SEWAGE DISPOSAL TESTING

STATE OF MARYLAND - DEPARTMENT OF HEALTH AND MENTAL HYGIENE

File No. F-81-75

FINAL PLAT.
GREEN PROPERTY
LOTS 1 & 2.
6TH ELECTION DISTRICT.
HOWARD COUNTY, MD.
JANUARY 12, 1981. SCALE: 1"=50'

HOLE PATTERN OF GOOD HOLES

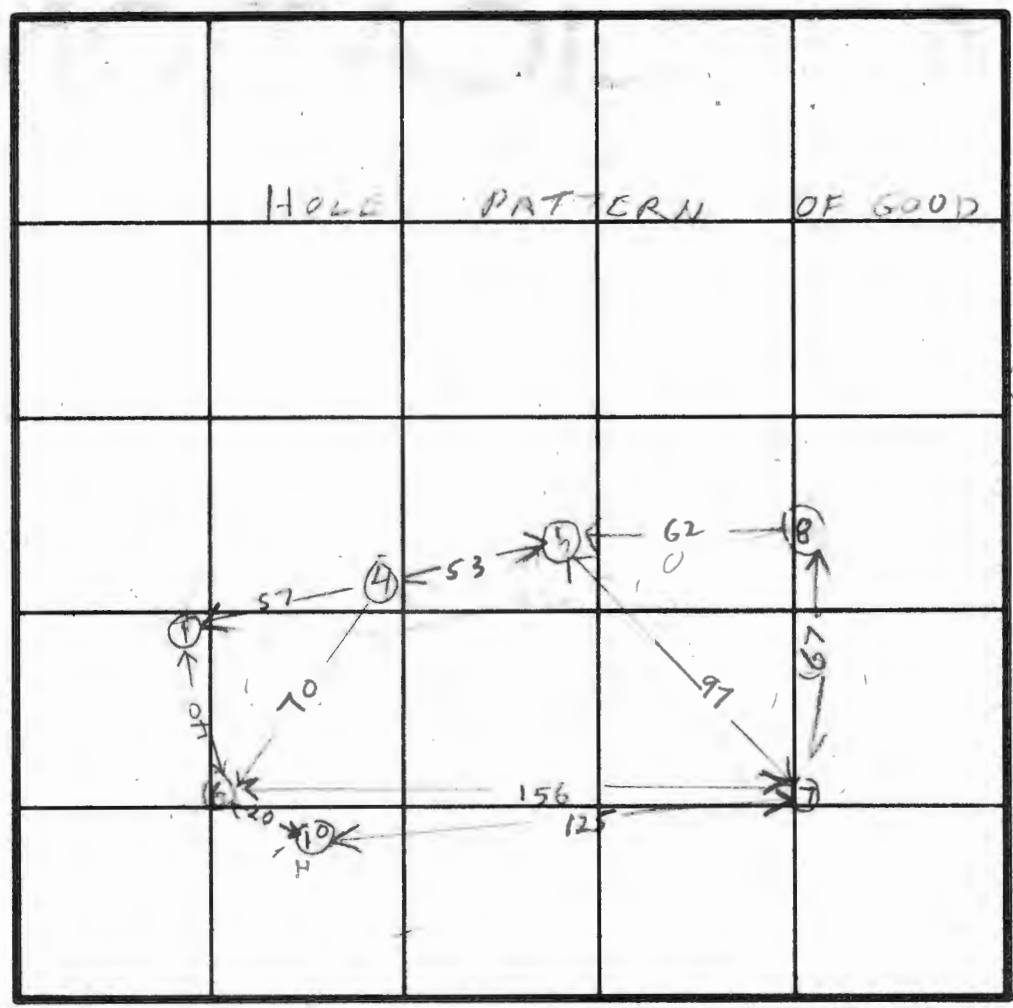
④ = LOWEST
⑥①⑩⑦ = HIGH

J. H. GREEN PROP.

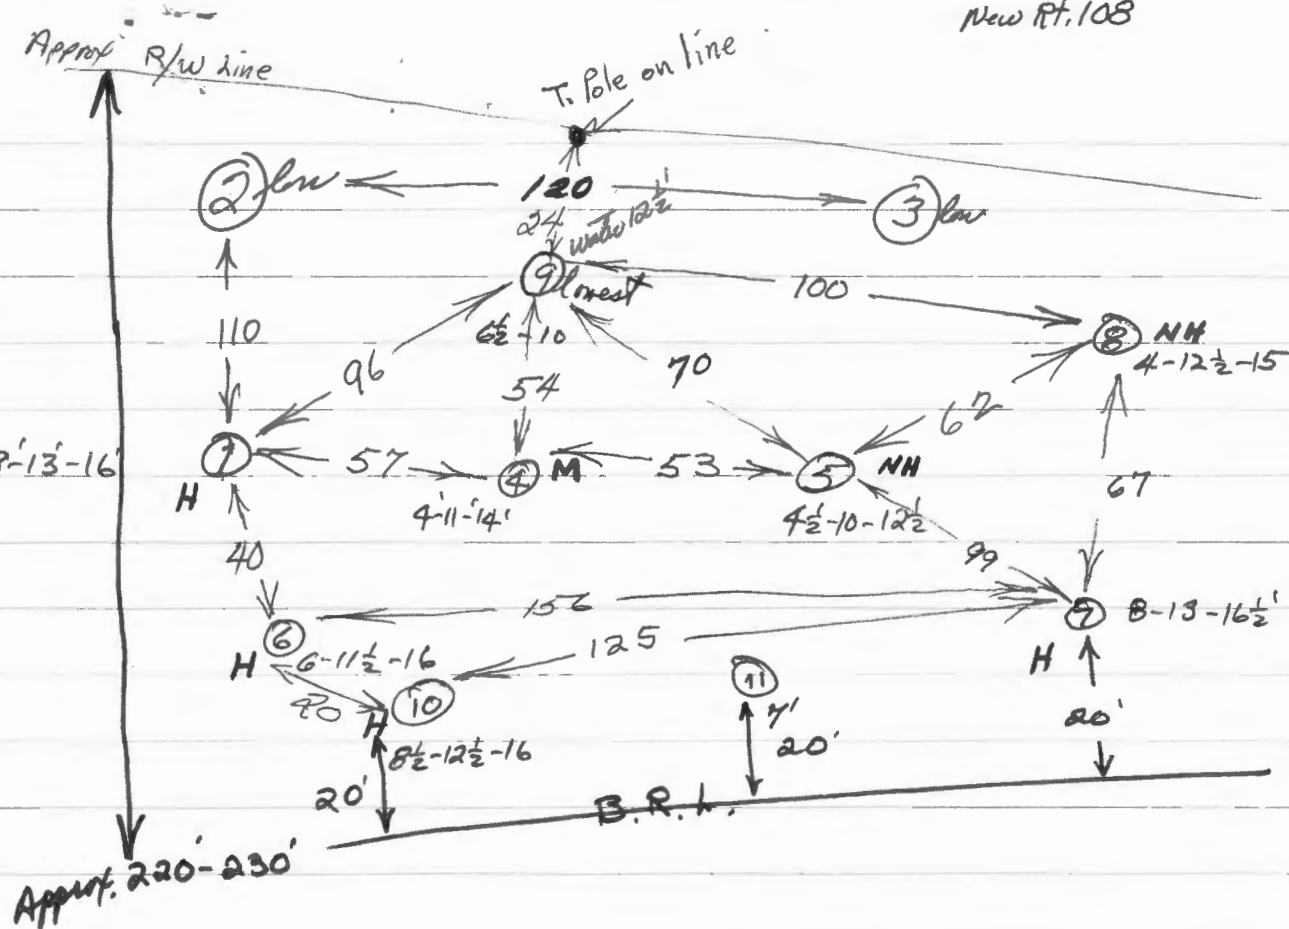
FF COMMENTS
IN RED BEFORE
TESTS TODAY

hole #				
1	6' fails	8' ok	13' ok	16 sandy
2	3' "		10 1/2' fails	
3	3' "		10 1/2' "	
4	4' ok	11' ok		14' top 6' clayish, but 3' sandy (top 3 1/2' clay then sand)
5	4 1/2' ok	10' ok		top 4' clay hard sand at 12 1/2'
6	6' ok	11 1/2' ok		16' top 5 1/2' clay, 16' sandy
7	8' ok	13' ok		16 1/2' sandy
8	4' ok	12 1/2' ok		15' sandy & some clay
9	6 1/2' ok	10' ok		14' water 12 1/2' top 5' clay
10	4' fails, 7 1/2' fails	8 1/2' ok		12 1/2' ok 16' sandy
11	V			7' - top 6' clayish, 1' hard sand

PROPOSED LOT 1 GREEN PROPERTY
 F- 8175 6th ELECTION DIST.
 HOWARD CO. MD
 1"=50' 2/13/81

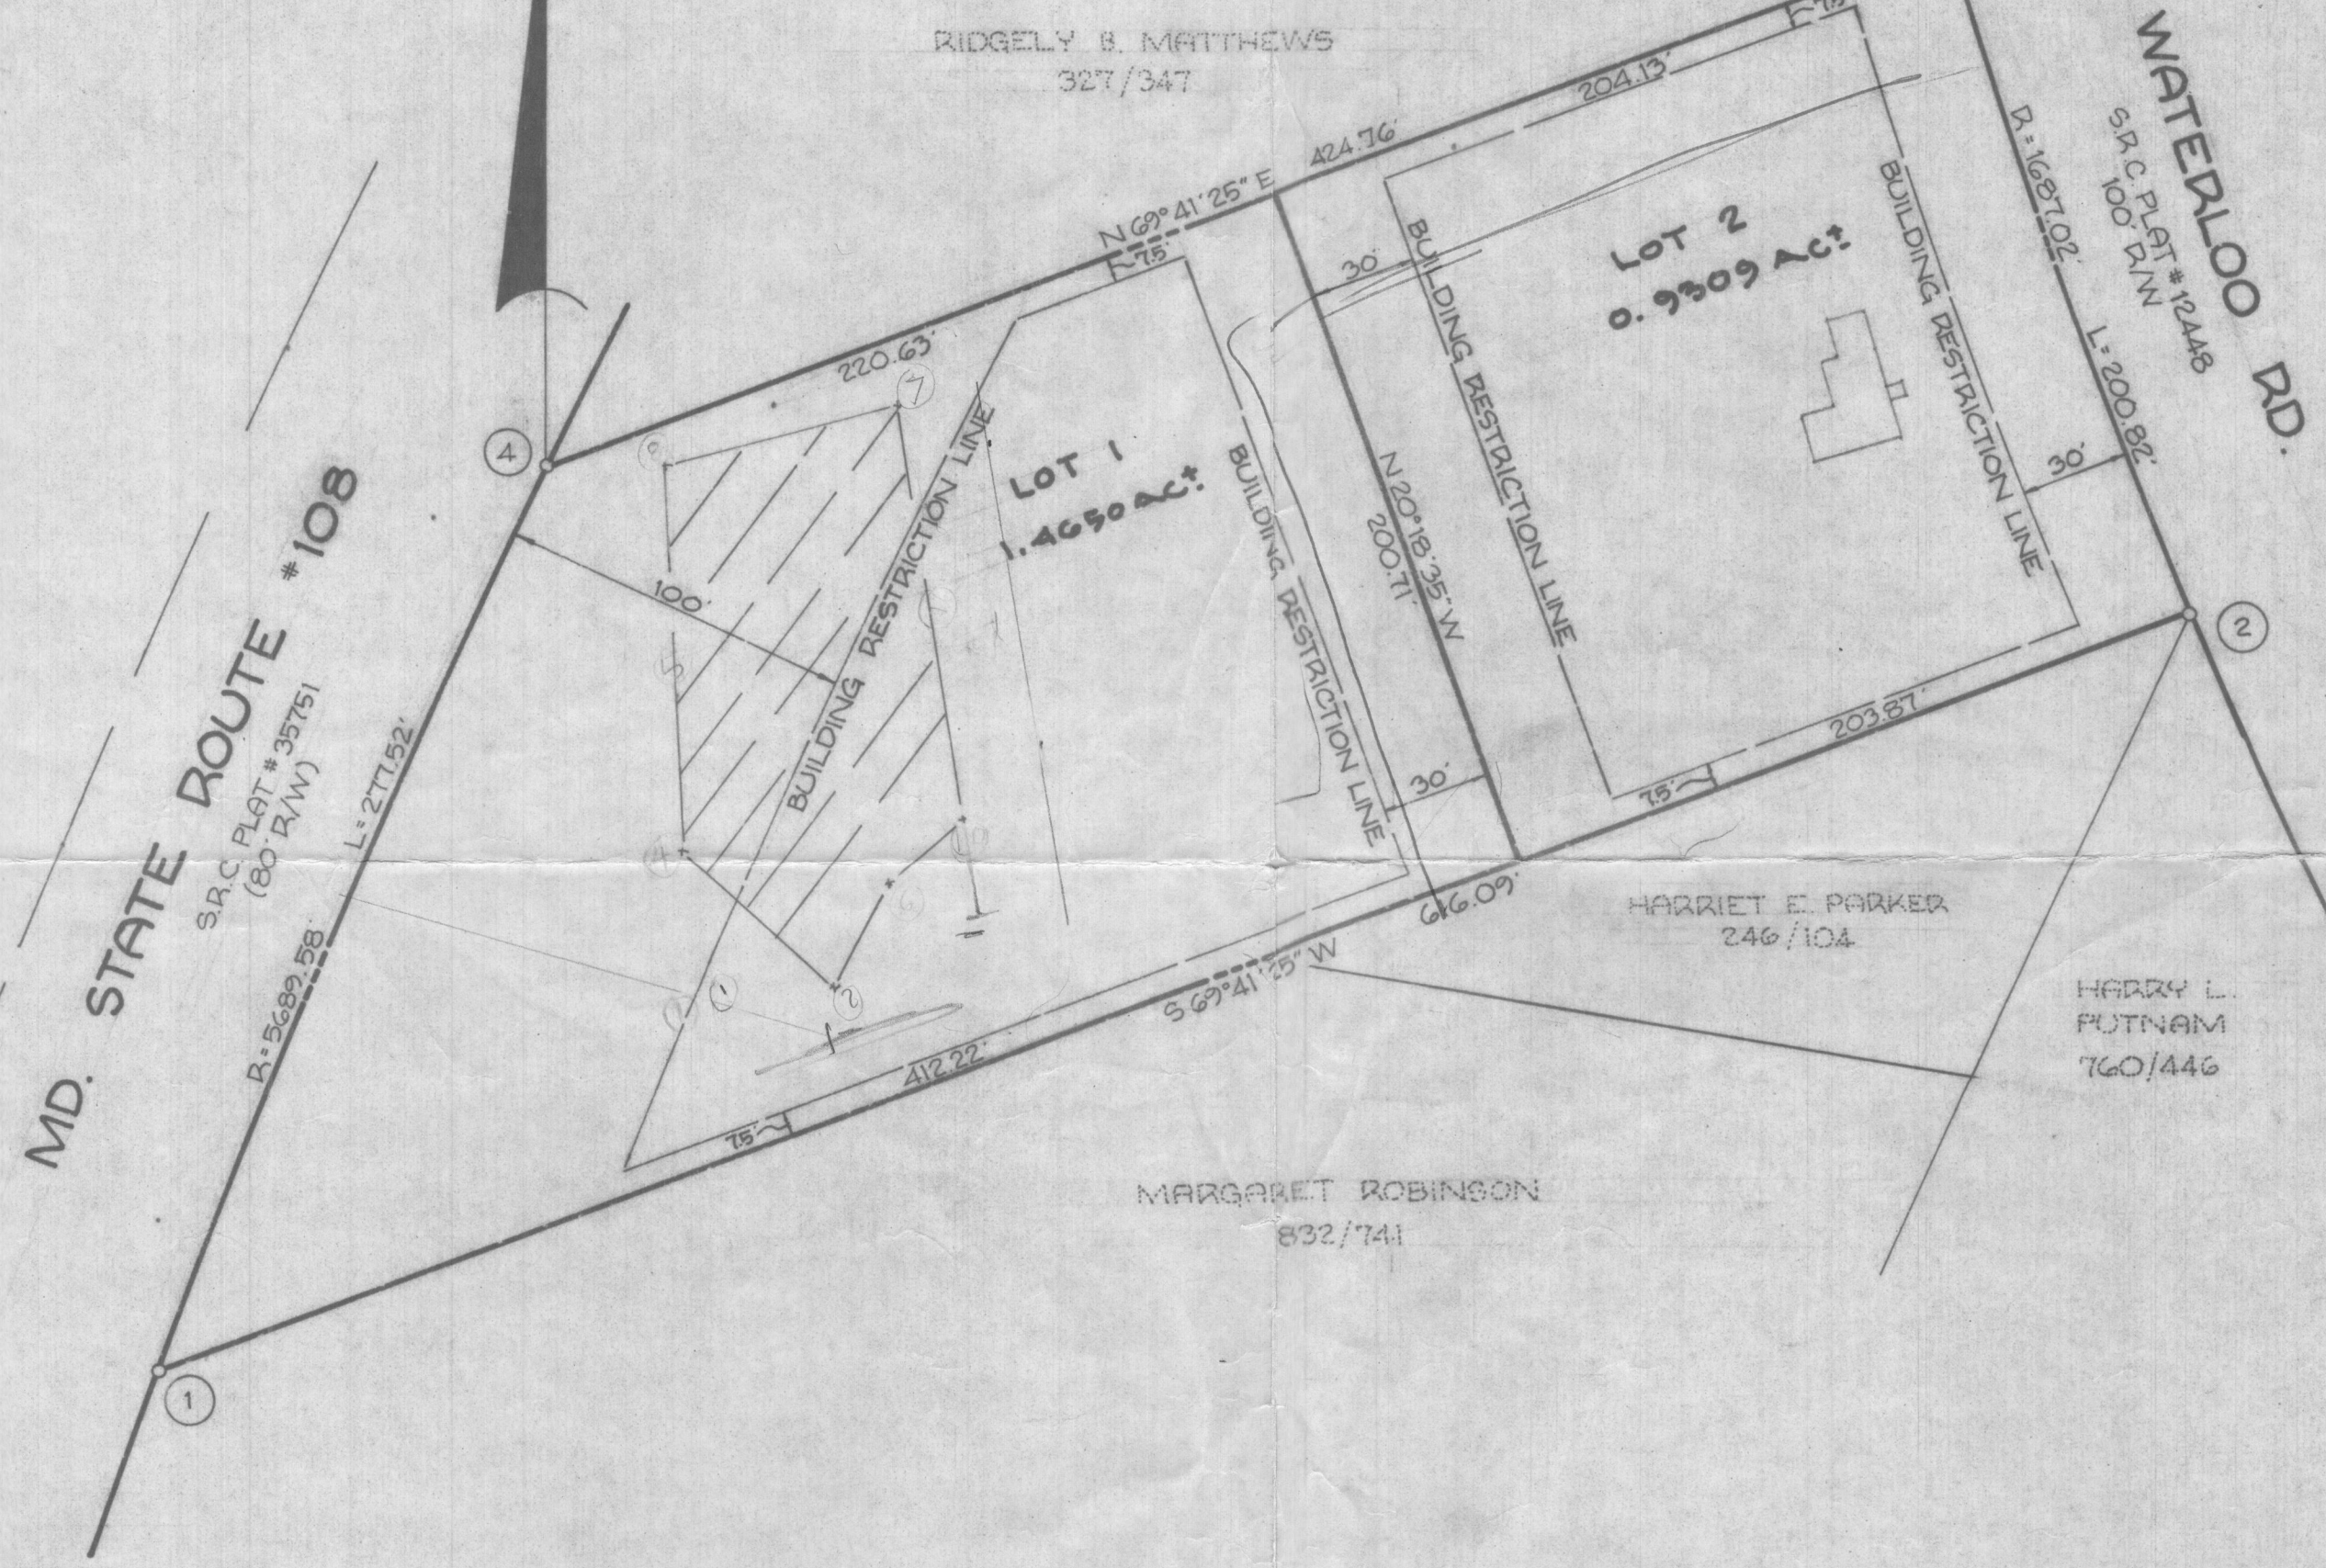
FIELD LOCATED
 PAVE HOLES

4-5-6-7-8-9 OK
 10 MARGINAL

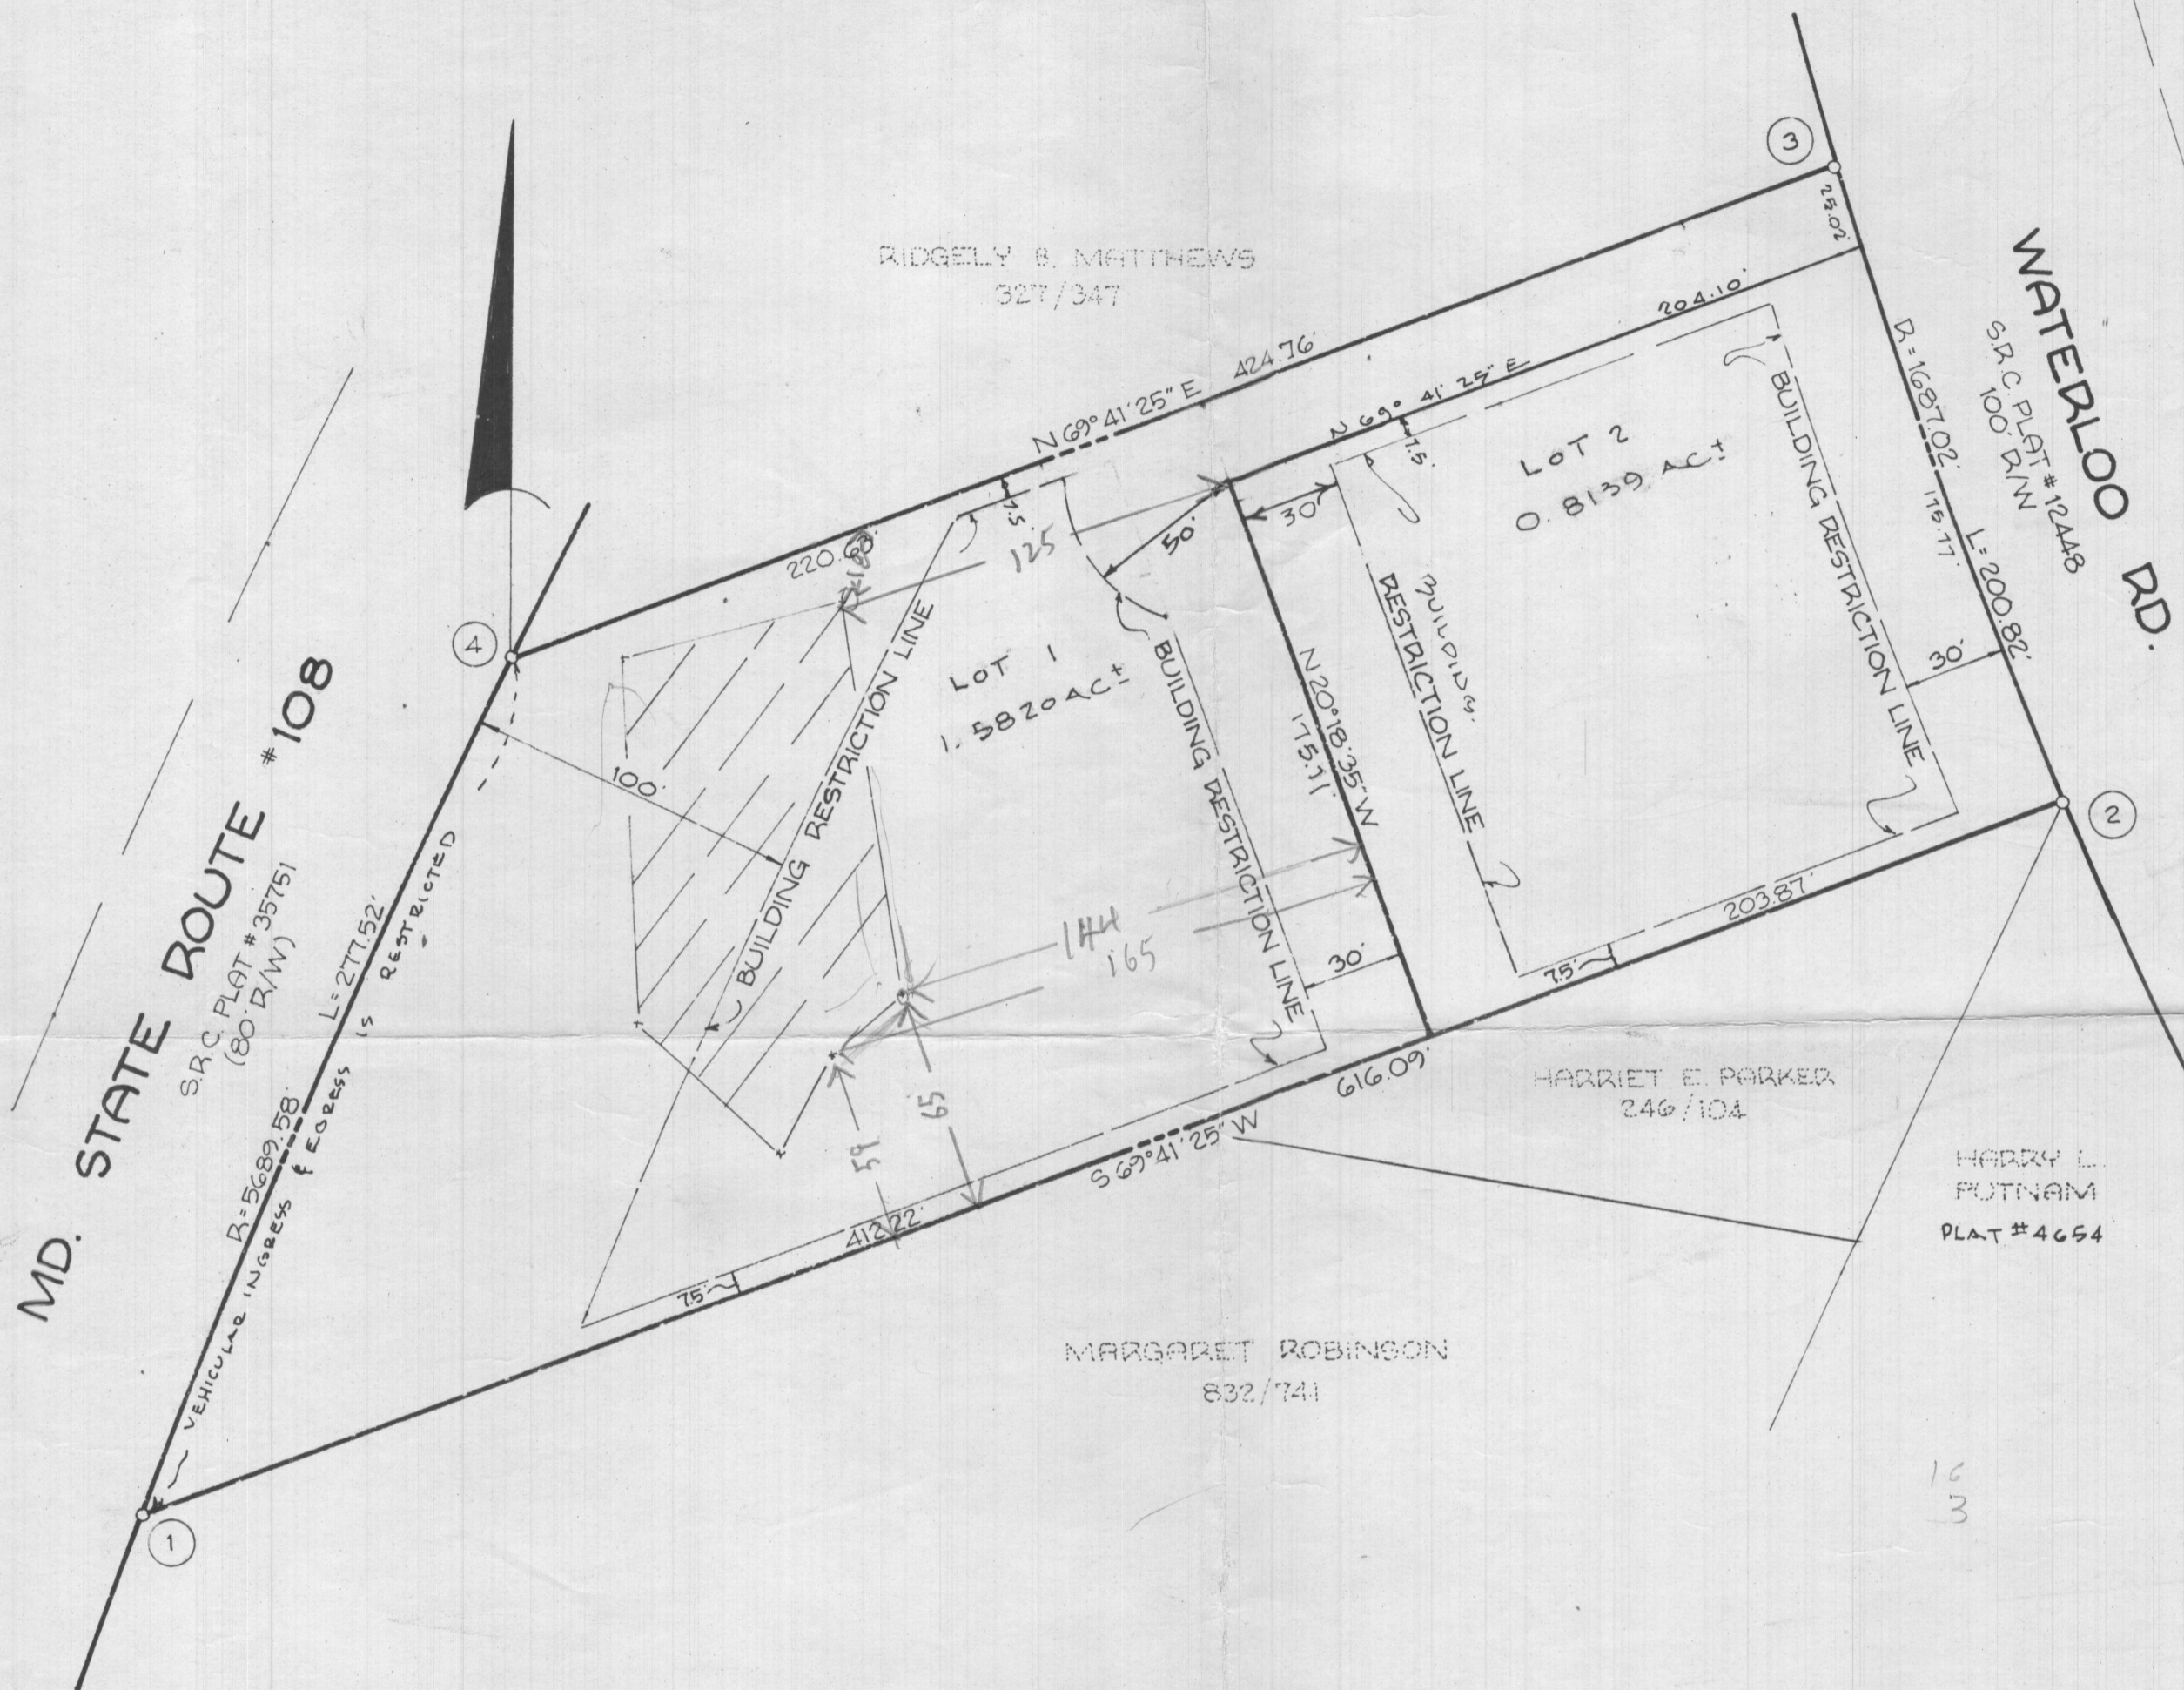
① Desirable to have per
tent plat but not required.

② We must have Data on Relative
Elevations of holes in order to
design system & also location & elevation of Bad Holes.

④ Memorandum ownership statement
required on Final
called Hudkins ass Busy

2/26/81 - Per Holes O/C except one of High
holes omitted General notes
needed on per certificate
plat & plan for IFC to sign
& also other lot & permanent hole statement

4/2/81 W. Park said Plat must be
redrawn to change entry R/W
Per Area not affected

Fogel Menum ownership statement

Park He is going to bring in Plat
show Locations & Elevations ^{TU 03 30 PM} 17 FEB 81

we would submit plat with notes
